STATION, RADIO, A13

TECHNICAL HANDBOOK - INDEX OF MODIFICATIONS

TECHNICAL HANDBOOK - MODIFICATION INSTRUCTION

SUB-TITLE: Reduction of r.f. amplifier cross modulation

Fig 6 - Part of circuit diagram after modification

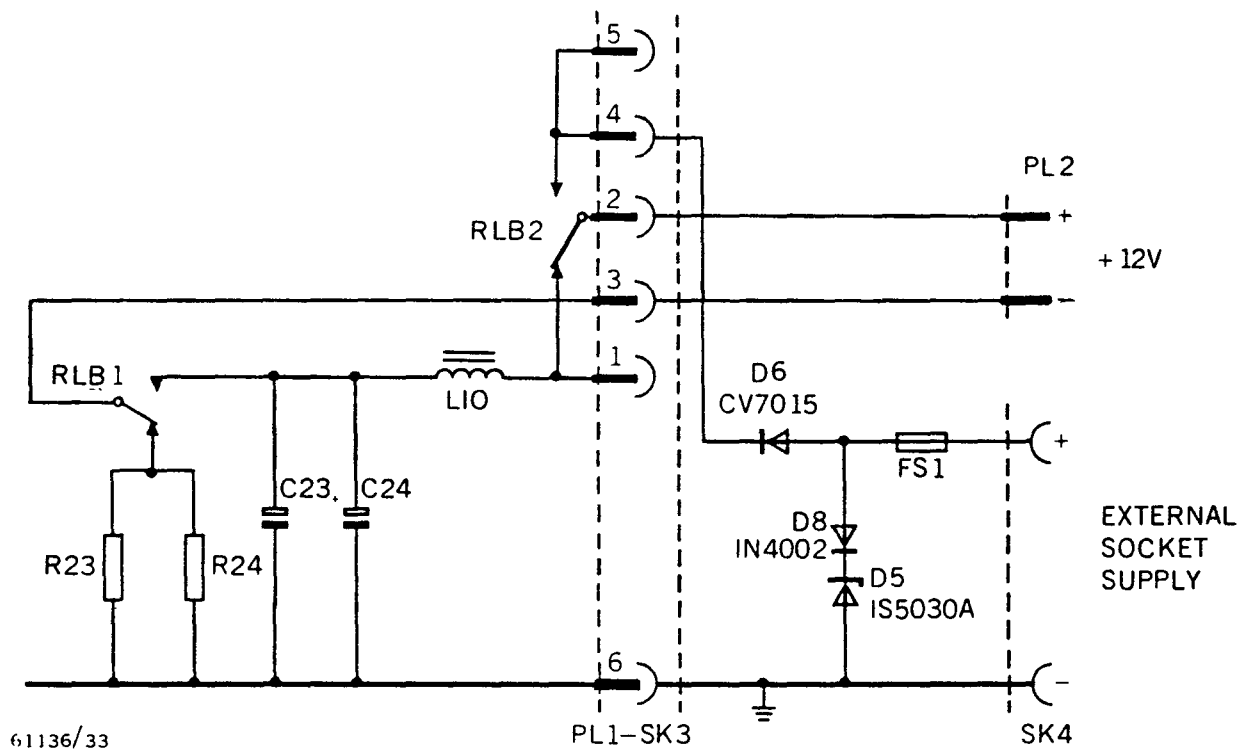
- a. Page 1136, Fig 2606, at foot of page
Add: Note: Alteration to circuit on embodiment of Mod Instr No 41. (Fig 6).
- b. Page 1138, Fig 2608, at foot of page
Add: Note: Alteration to serial 8 top right hand corner on embodiment of Mod Instr No 41. (Fig 3).
- c. Page 1140, Fig 2610, at foot of page
Add: Note: Addition of R23 and R24 in cct ref DE 2, 3, on embodiment of Mod Instr No 41. (Fig 2).

Fig 2 - Board 25 after modification

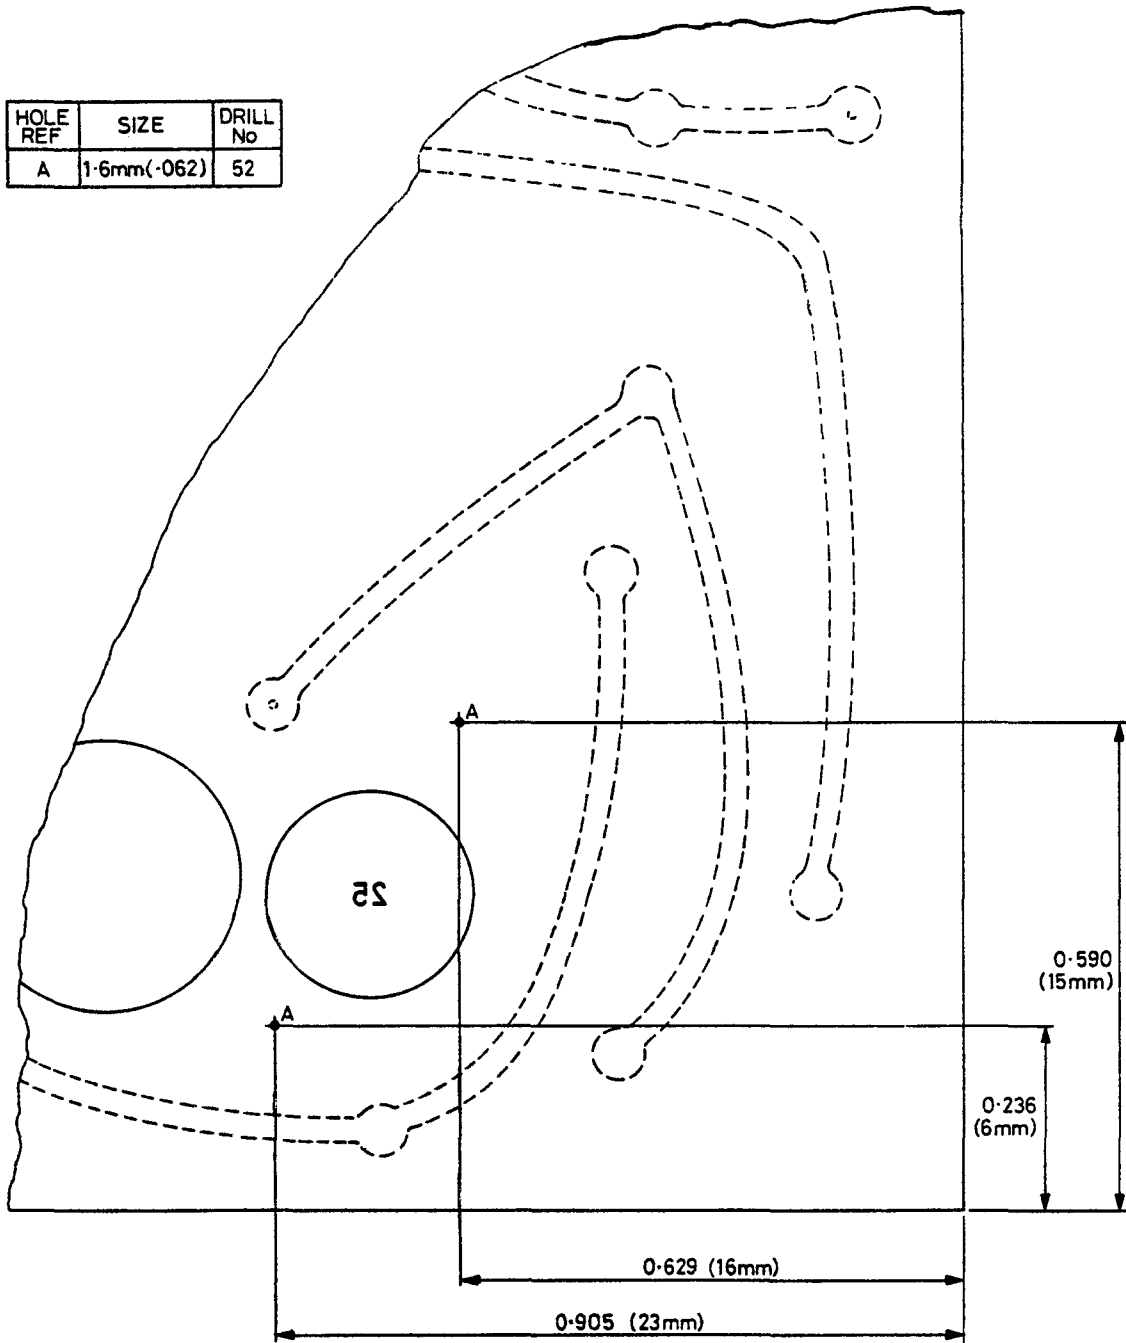
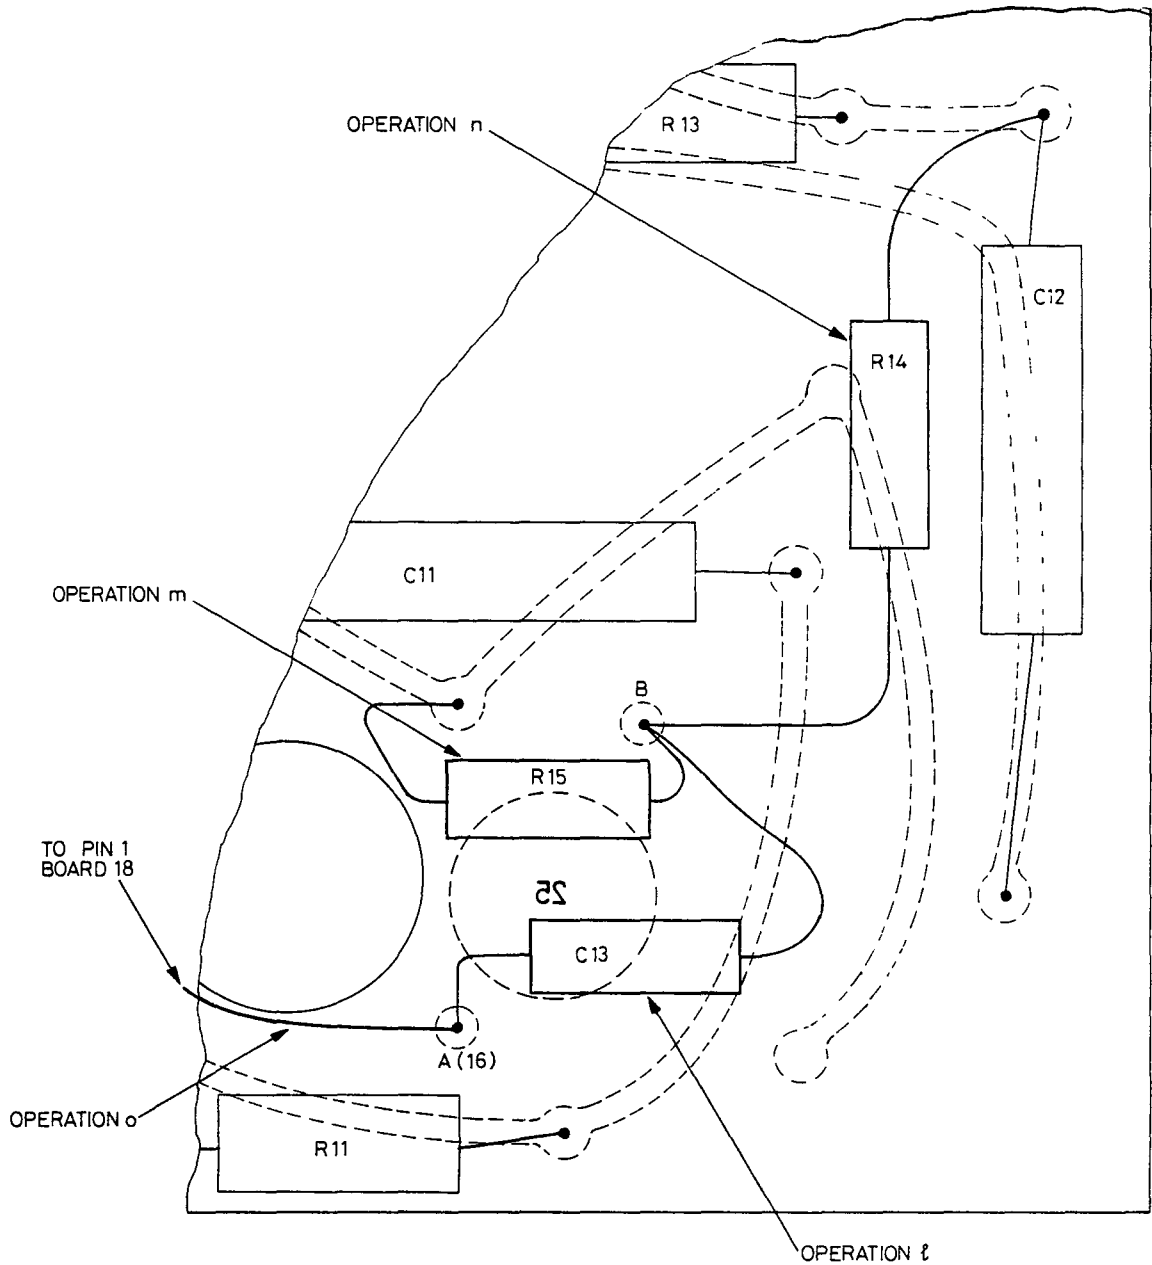
t. Solder the remaining end of Wire Electrical 26 s.w.g., fitted in operation o, to pin 1 (board 18) as indicated in Fig 2.
